CITY OF PROVIDENCE
BUILDING BOARD OF REVIEW

APPLICATION APPEALING THE DECISION OF THE BUILDING OFFICIAL, OR
FOR A VARIATION OR MODIFICATION FROM CERTAIN SECTIONS OF THE RI STATE BUILDING CODE

1. Subject Department of inspection + Standards Permit Number: BLDG-24-1304
2. Street Address of Subject Property: 46 Zone Street
 Assessor's Plat and Lot Numbers of Subject Property: 66-178
3. Base Zoning District(s): R-3
 Overlay District(s): None

NOTICE OF REFUSAL OF PERMIT APPLICATION	CITY OF PROVIDENCE DEPT OF INSPECTIONS AND STANDARDS 444 Westminster Street -Providence, RI. 02903 Joseph A. Doorley – Municipal Building		APPLICATION DATE 09/26/2024	APPLICATION NO. BLDG-24-1304
			DATE OF REFUSAL 03/31/2025	A P P E A L F E E \$440
LOCATION 46 Zone St. Providence, RI 02908		PAGE NUMBER 1 of 1		
APPLICANT Wei Ma	TITLE Applicant/Owner	ADDRESS 461 Maple Ave. Barrington , RI 02806		
PROPERTY OWNER'S NAME Wei Ma		PROPERTY OWNER'S FULL ADDRESS 461 Maple Ave. Barrington, RI 02806		
THE APPLICATION FOR A CERTIFICATE OF OCCUPANCY FOR THE ABOVE LOCATION HAS BEEN REFUSED BECAUSE THE PROVISIONS OF THE RHODE ISLAND STATE CODE HAVE NOT BEEN COMPLIED WITH IN THE FOLLOWING PARTICULARS.				
SCOPE OF PERMI

FIRE AND LIFE SAFETY
PLANS BASEMENT, 1ST
FL, 2ND FL & 3RD FL

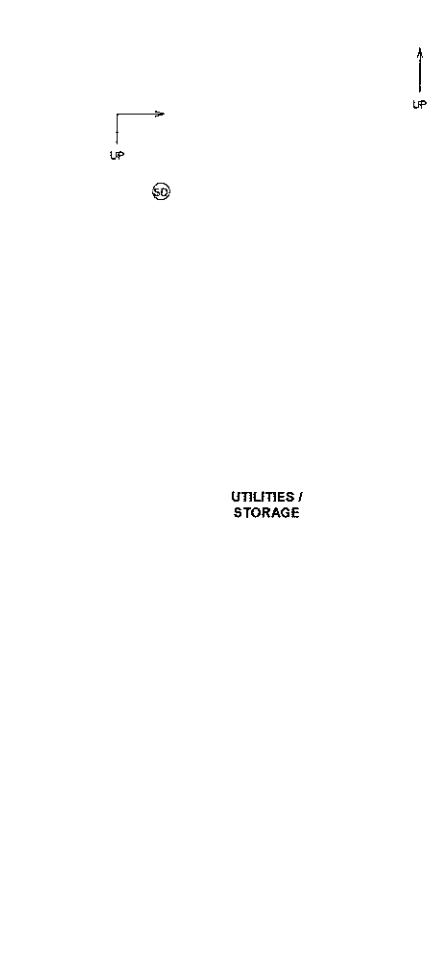
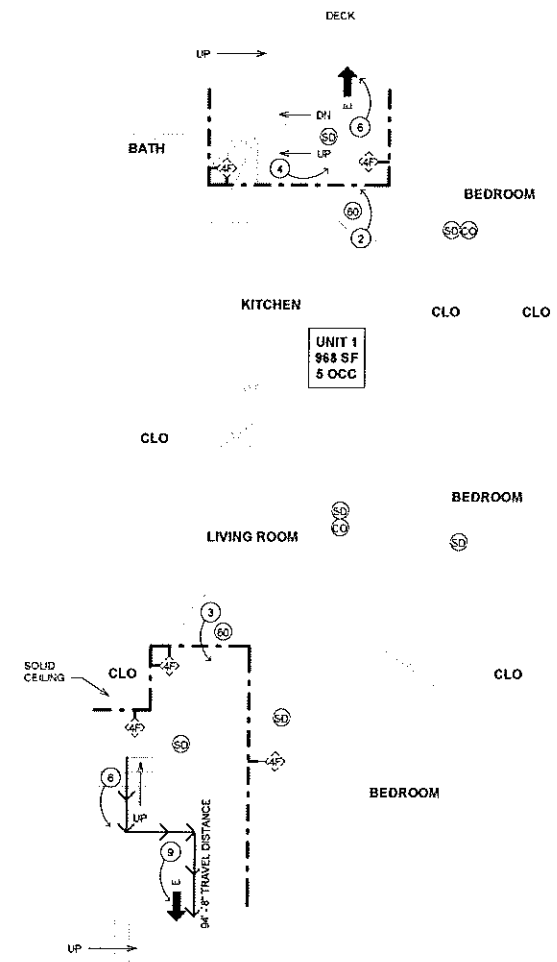
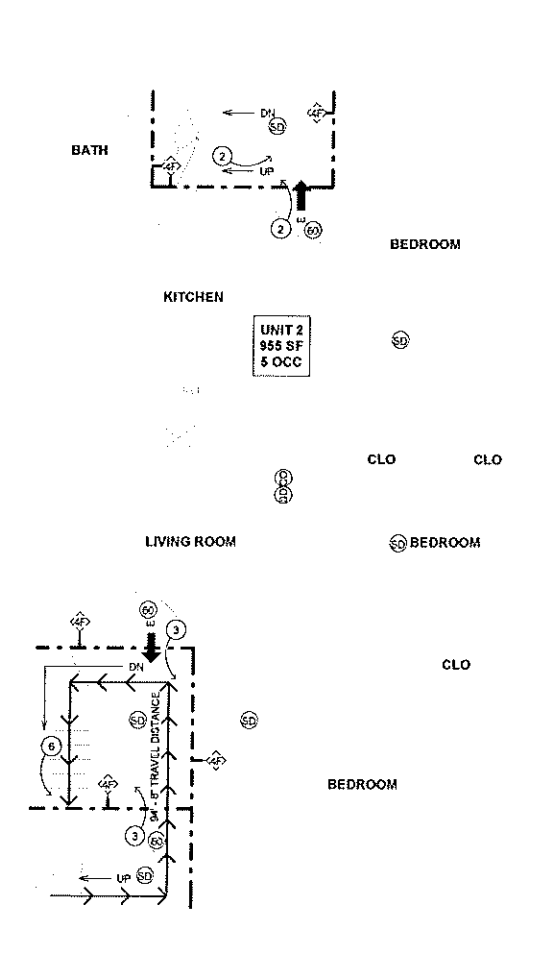
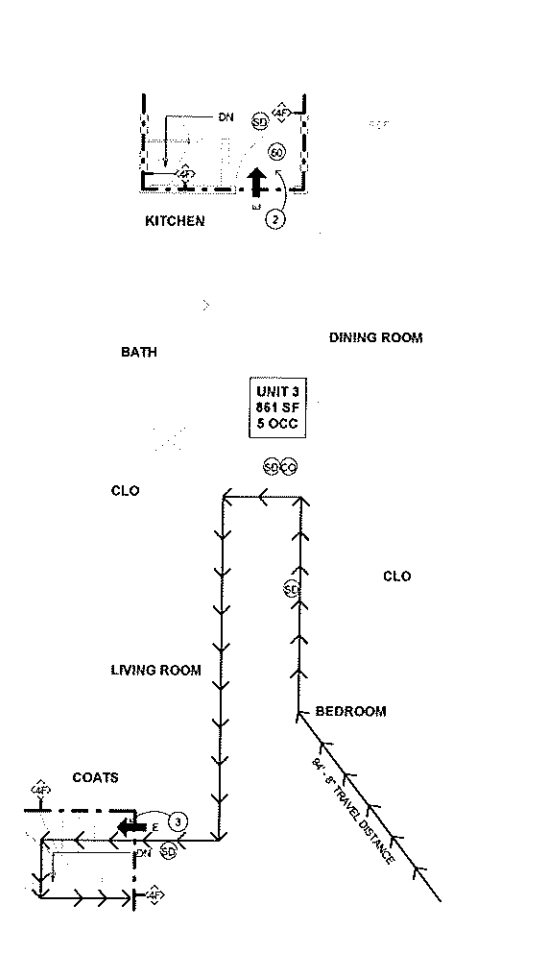
**	Whereas, the proposed stairs are non-compliant with the dimensional standards.			
Section 1023.2	Interior Exit Stairways-Construction. Enclosures for interior exit stairways shall be constructed as fire barriers in accordance with Section 707 or horizontal assemblies constructed in accordance with Section 711, or both. Interior exit stairway and ramp enclosures shall have a fire-resistance rating of not less than 2 hours where connecting four stories or more.

**	Whereas, the West stairs are 1 hour fire-rated.			
Section 1206.2	Airborne sound. Walls, partitions and floor-ceiling assemblies separating dwelling units and sleeping units from each other or from public or service areas shall have a sound transmission class of not less than 50, or not less than 45 if field tested, for airborne noise where tested in accordance with ASTM E90.

This existing home has existing stairs, front and rear. These stairs have plaster walls, assumed 1 hour per the Rhode Island Rehab Code. These stairs connect three levels, with the rear stair also connecting to the basement. We would like these stairs to remain without any changes.

C1 FLOOR PLAN - 3RD FL
1/4" = 1'-0"

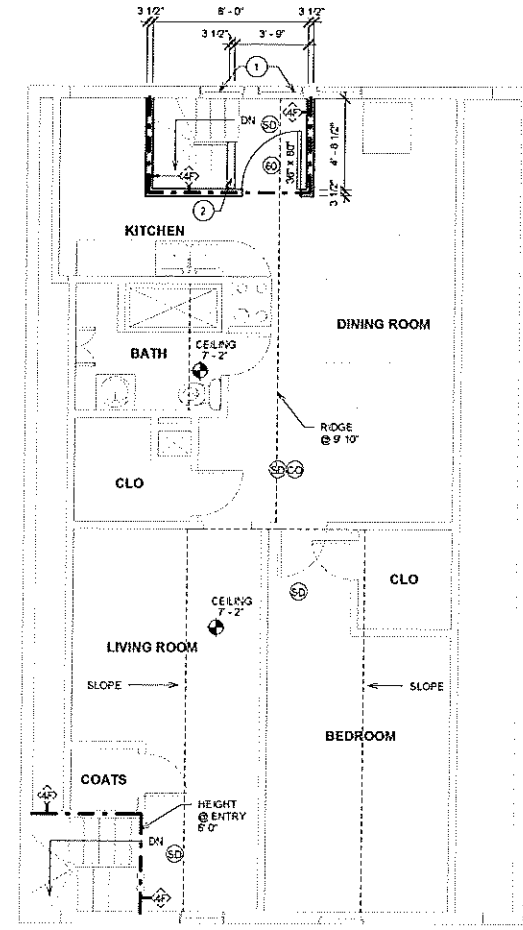
Section 1207.2	<p>Minimum ceiling heights. Occupiable spaces, habitable spaces and corridors shall have a ceiling height of not less than 7 feet 6 inches (2286 mm) above the finished floor. Bathrooms, toilet rooms, kitchens, storage rooms and laundry rooms shall have a ceiling height of not less than 7 feet (2134 mm) above the finished floor.</p> <p><u>Exceptions:</u> #2. If any room in a building has a sloped ceiling, the prescribed ceiling height for the room is required in one-half the area thereof. Any portion of the room measuring less than 5 feet (1524 mm) from the finished floor to the ceiling shall not be included in any computation of the minimum area thereof.</p>
**	Whereas, the East stair clearance is 6 ft.

This existing home was built many years ago. The third floor has non-compliant ceiling heights in some rooms. Additionally, the front stairwell has a non-compliant ceiling height at the third level. We request that these conditions are allowed to remain.
